**TOWN OF LOS GATOS
FIFTH STAFF TECHNICAL
REVIEW COMMENTS**

**STAFF TECHNICAL REVIEW
PLANNING DIVISION
September 17, 2025**

**ITEM 4: 14288 Capri Drive
Architecture and Site Application S-24-044**

Requesting Approval for Demolition of an Existing Commercial Building, Construction of a Multi-Family Residential Development (119 Apartment Units), Site Work Requiring a Grading Permit, and Removal of Large Protected Trees Under Senate Bill 330 (SB 330) on Property Zoned C-1. APN 406-30-016. CEQA Review is Pending.

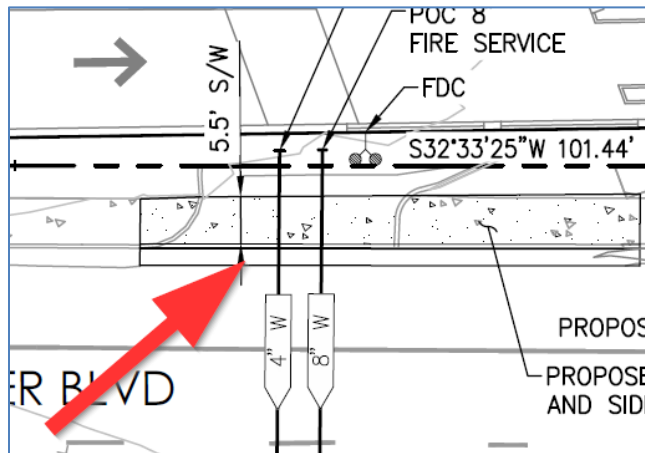
box trees or (54) 36" box trees. As proposed, only (23) 36" box trees are proposed, which would be short of the requirement by (31) 36" box trees or (62) 24" box trees. This would require an in-lieu payment of \$15,500 per Town Code. However, several of these trees may be exempt from the replacement requirement if they are determined to be "fruit-bearing" (Trees 10, 17, 20, 21, 26, 27, 30-36, and 39). This could drastically reduce the in-lieu fee.

New Sheet DG0.2:

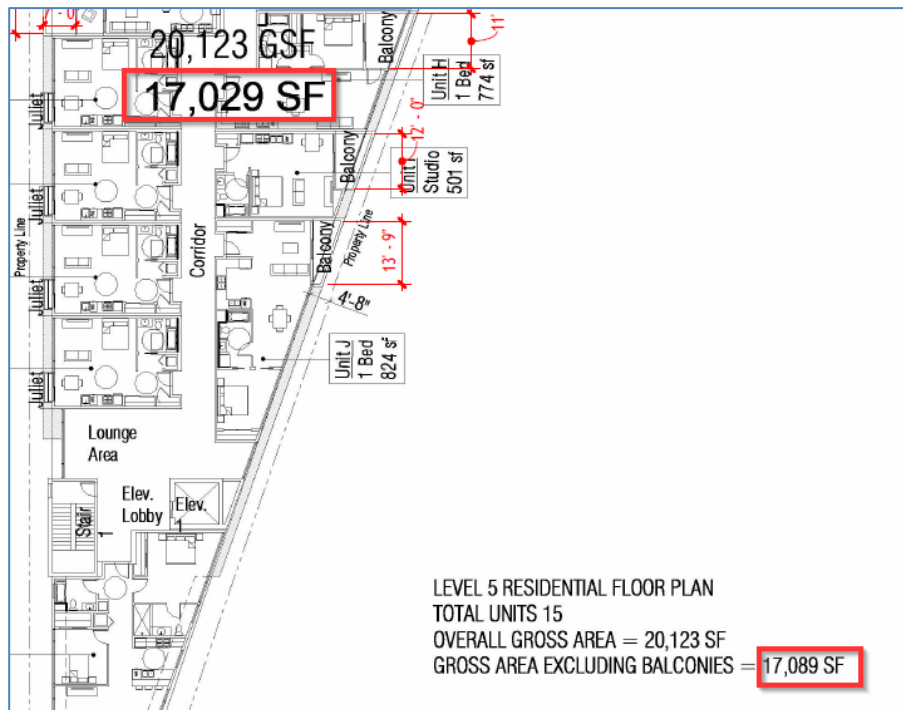
- 91) ~~Floor plan note 1 says there are 120 long-term bike parking spaces, when there are 166.~~
- 92) ~~Floor plan note 2 says to see detail DG0.1/3 for long-term bike parking details. Detail DG0.1/3 is a short-term space.~~
- 93) Plans were updated and now the long term bike parking notes are inconsistent. Ensure that in each table below, the floor plan matches the actual floor plan. For example, Level 3 floor

- plan table shows 52 long term bike spaces, while the call-out notes show 32 and 24 (56 total), and the call-out for 24 bike spaces is pointing to bike room 3, which shows 20 bikes. Similarly, Floor Plan Note 1 needs to be updated as the updated count is no longer 140, and bike parking is proposed on the first floor and not just levels 2-4. See below screenshot.
- 94) A new “continuous wheel stop see note 2” call-out was added, but note 2 does not correspond to wheel stops. Update accordingly.
- 95) A new “sunshade device outline” call-out was added, but the dimension is not noted. Specify how far it overhangs beyond the wall.
- 96) The dimensions for the southernmost architectural awning (above the lounge) are not accurate. The dimensions measure to the property line, and this awning does not extend that far.

Sheet A2.1:

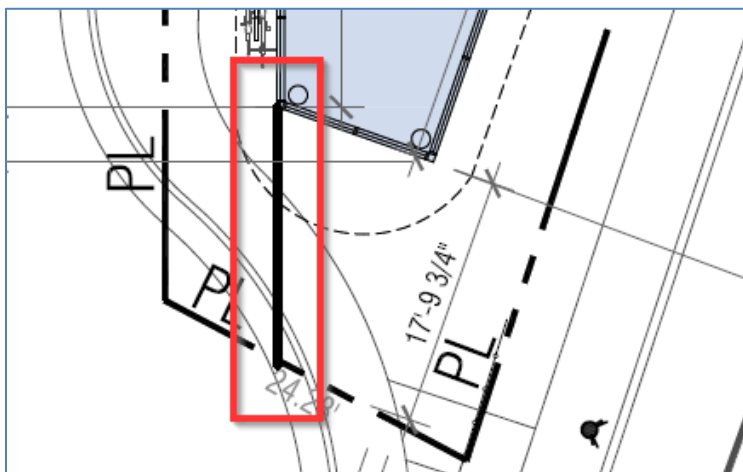
- 128) The revised cul-de-sac radius note (32') does not match the rest of the plans.
- 129) The sheet says "(E) cul-de-sac." There is no existing cul-de-sac at the site.
